# **UT to Cane Creek Restoration Project Year 5 FINAL Monitoring Report**

Subject: Task 11: Response Letter to DMS review comments regarding the Draft Year 5 Monitoring Report for the UT to Cane Creek Restoration Project (#95729)  
Cape Fear Basin – CU#03030002, Alamance County, North Carolina  
Service Contract No. 004951, DMS No. 95729, RFP No. 16-004357, Baker No. 132700

Looking at the Left Bank

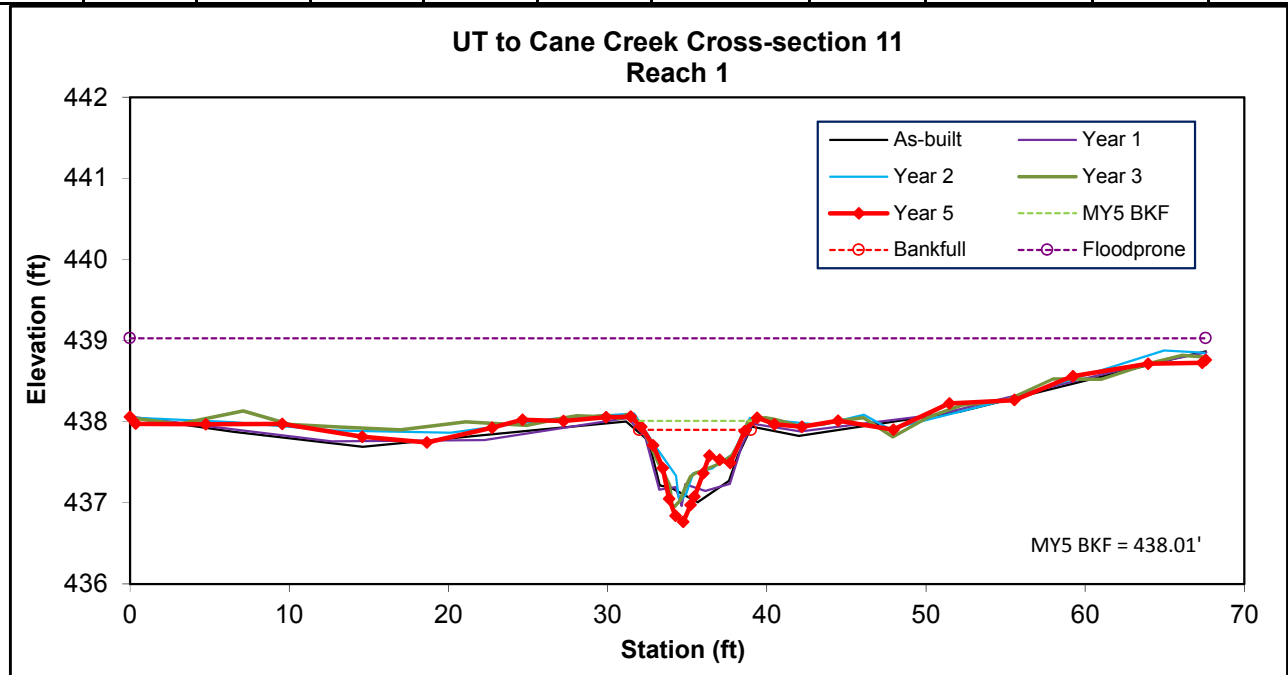
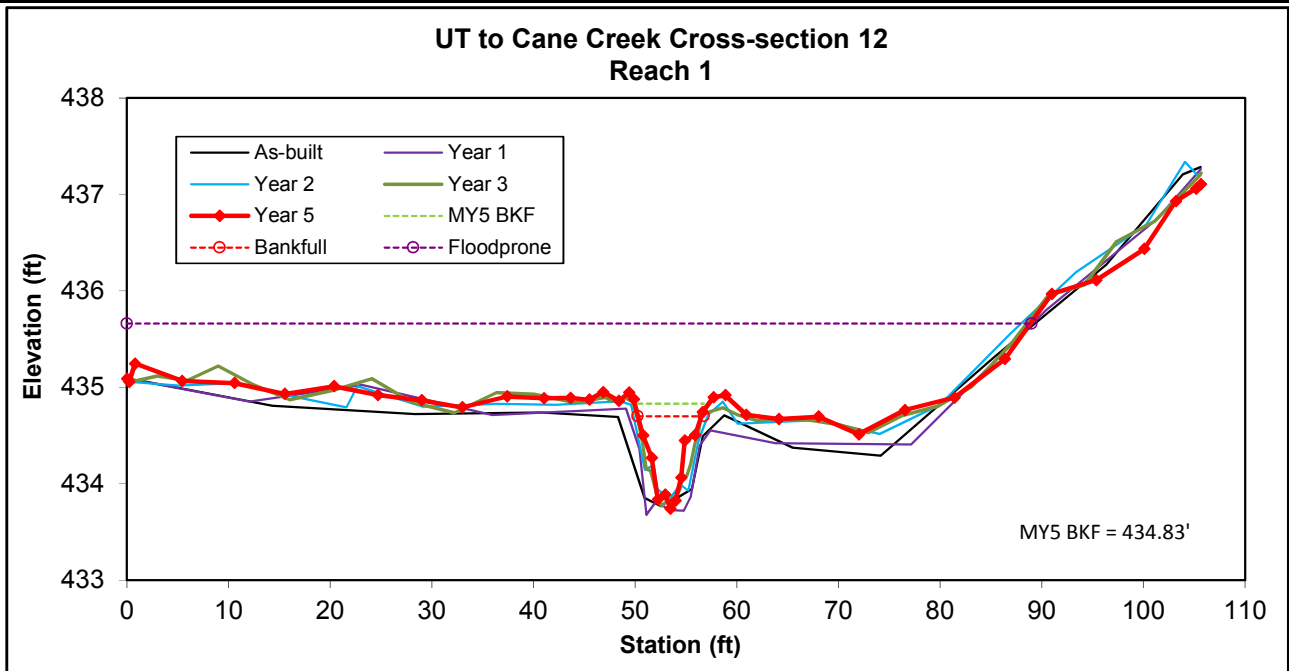
3. Appendix D, Table 11: During our review of the Bank Height Ratios (BHR) in Table 11, DMS staff performs a visual comparison of the MY5 data to As-Built/Baseline cross-sections. DMS noted/realized that by displaying the As-built Bankfull Cross-Sectional Area alone, the calculation for the BHR can be difficult to reconcile. We noted possible discrepancies in the BHR calculations for cross-sections 5, 9, 11 and 12 given this disconnect. Using the new BHR calculation methodology where the As-Built Bankfull Area is held constant, please display the Year 5 bankfull elevation as another data series just for the sake of clarity between the BHR calculation and the overlay. It appears that the BHR calculations were done correctly, but just please add the MY5 bankfull data series with its elevation for the sake of clarity to the reader.

**Response:** An additional data series was added to each cross-section figure showing the MY5 bankfull line (generated using the as-built bankfull area as per the recent DMS memo) as requested. The BHR calculations for the three listed cross-sections were re-checked again and were all confirmed as correct. With the new bankfull line shown, a visual comparison between it and the MY5 cross-section data certainly makes the BHR values appear to make intuitive sense.
